AGENDA
Regular Hybrid Meeting
Town of Granby
Inland Wetlands and Watercourses Commission
Wednesday, August 13, 2025, at 7:00 pm
Town Hall Meeting Room

MEETING MINUTES
Town of Granby
Inland Wetlands and Watercourses Commission
Wednesday, July 9, 2025, at 7:00 pm

This letter is being submitted by Kimley-Horn & Associates, Inc. on behalf of AutoZone, Inc. ("Applicant") in response to the department review letters listed below:

SHEET NUMBER
C-3.0

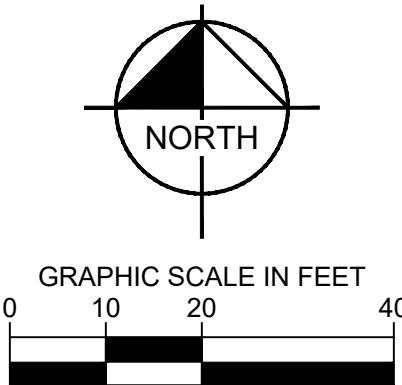
2. Show test hole information on this sheet.

3. Add the test hole pit data to the report and on sheet C-3.0. Test pits and soil data reporting to comply with the Connecticut Stormwater Quality Manual, March 30, 2024, Chapter 10, Test pits and Borings, pages 178 and 179.

Response: Sheet C-3.0 has been revised to include the test pit information (testing elevation and infiltration rate).

Response: Test pit data is included in the SWMP on page 14 and the full geotechnical report is provided in Appendix A.

Per the CT Stormwater Quality Manual, if the infiltration rate exceeds 8.3 in/hr, then 100% of the stormwater quality volume requirement must be treated using a different stormwater management practice before entering the infiltration basin. Therefore, the project stormwater management plan has been revised to include a bioretention basin before the

infiltration basin to treat the required water quality volume. The provided site plans and SWMP have been revised to include the bioretention location and details.
